revisions	description	date
05	Issued for Addendum 004	2022.01.08
04	Issued for Tender	2021.08.17
03	Issued for Tender	2020.09.30
02	Re-Issued for Review	2016.08.04
01	Issued for Review	2016.03.14

BAY 3 REFIT PROJECT

ELECTRICAL SINGLE
LINE DIAGRAM

2 SINGLE LINE DIAGRAM
NEW WORK

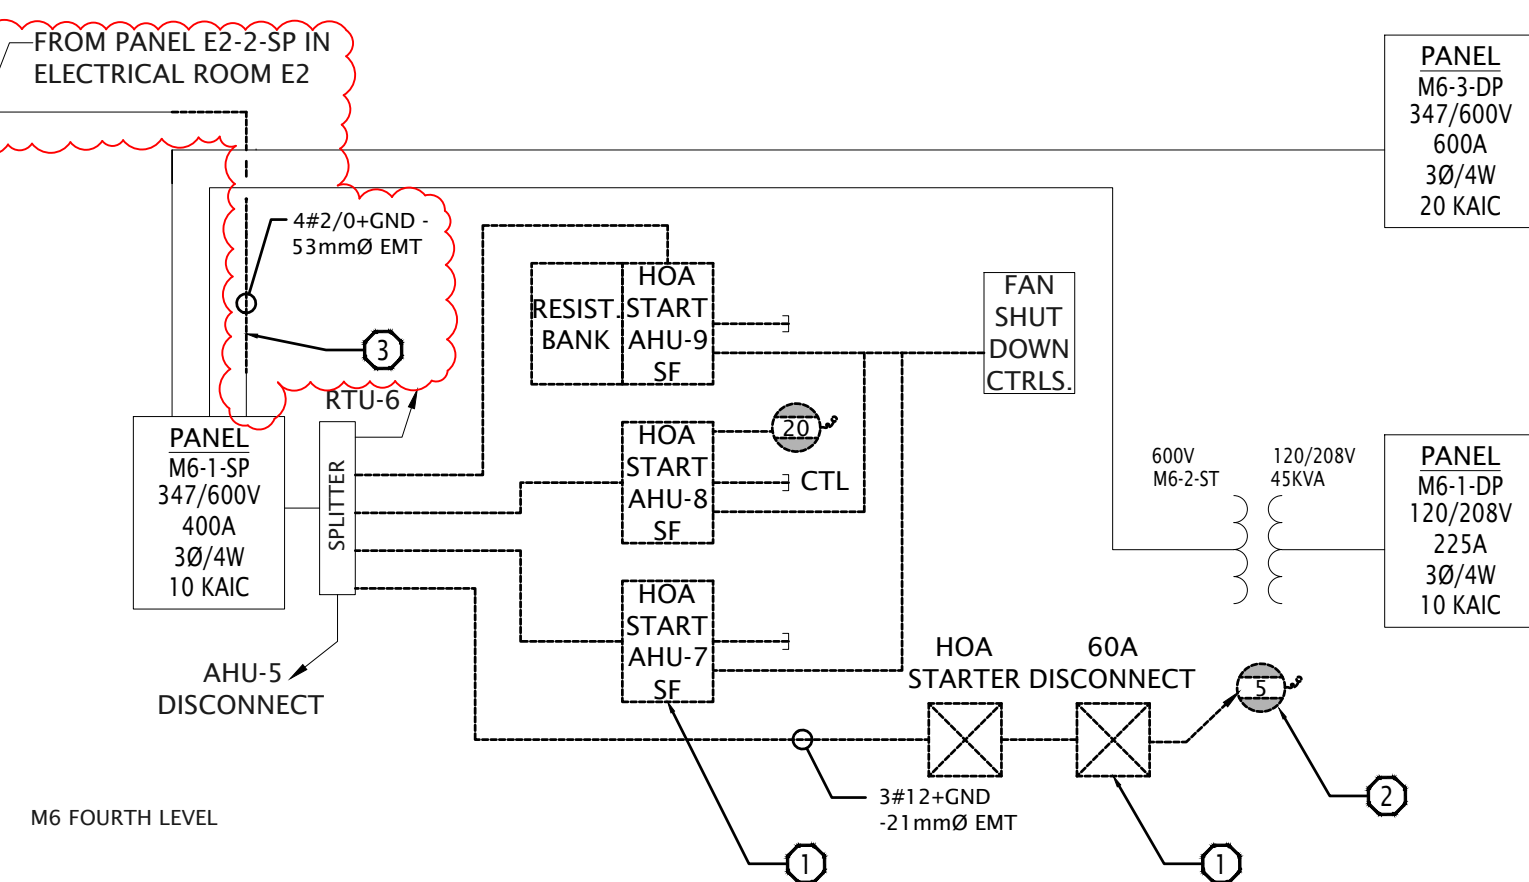
- 1 TYPICAL (OF 2 AHU UNITS):
PROVIDE 600V CONNECTION C/W CONDUIT AND WIRING TO FACTORY MOUNTED DISCONNECT. PROVIDE CONNECTION FROM DISCONNECT TO VFD AND FROM VFDs TO FANS.
- 2 TYPICAL (OF 2):
PROVIDE TWO (2) 15A CIRCUITS TO LIGHTING AND CONTROLS, AND ONE (1) 20A CIRCUIT TO MAINTENANCE RECEPTACLE.
- 3 REFER TO PHASE DRAWINGS. WORK TO BE PERFORMED IN TWO SEPARATE PHASES.
- 4 PROVIDE SPLITTER (600V, 225A, 3P, 4W) C/W SUPPORTS AND CONNECT TO CIRCUIT INTERCEPTED AND RETAINED IN DEMOLITION. MODIFY AND EXTEND CONDUIT AND WIRING AS REQUIRED.
- 5 PROVIDE CONNECTION TO PANEL M6-1-SP FROM SPLITTER USING CIRCUIT RETAINED IN DEMOLITION. MODIFY AND EXTEND CONDUIT AND WIRING AS REQUIRED.
- 6 TYPICAL:
PROVIDE DISCONNECT SWITCHES (RATING AS IDENTIFIED ON SINGLE LINE DIAGRAM) IN LOCATION OF REMOVED STARTERS TO SERVE AHU-7 AND AHU-8 C/W CONDUIT AND WIRING.

1 SINGLE LINE DIAGRAM
DEMOLITION

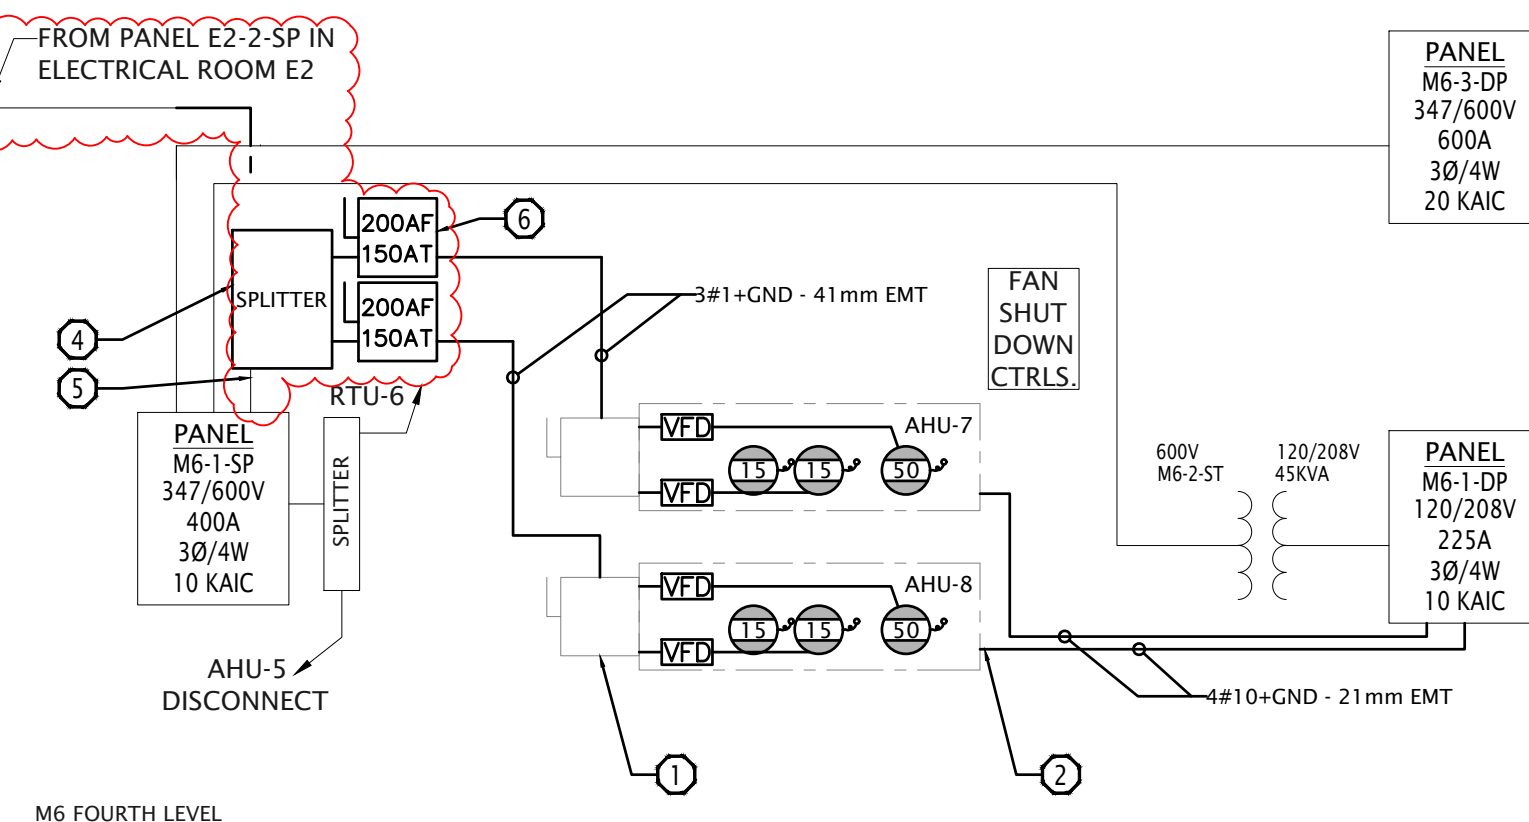
- 1 TYPICAL:
DISCONNECT AND REMOVE IDENTIFIED STARTERS AND CONDUIT BACK TO SOURCE.
- 2 TYPICAL:
DISCONNECT SUPPLY FAN (SF) AND RETURN FAN (RF) MOTORS FOR AHU-8. REMOVAL BY MECHANICAL TRADES.
- 3 INTERCEPT INCOMING FEEDER SERVING M6-1-SP AS REQUIRED TO ALLOW FOR SPLITTER IN NEW CONSTRUCTION. RETAIN WIRING FOR REUSE IN NEW CONSTRUCTION.
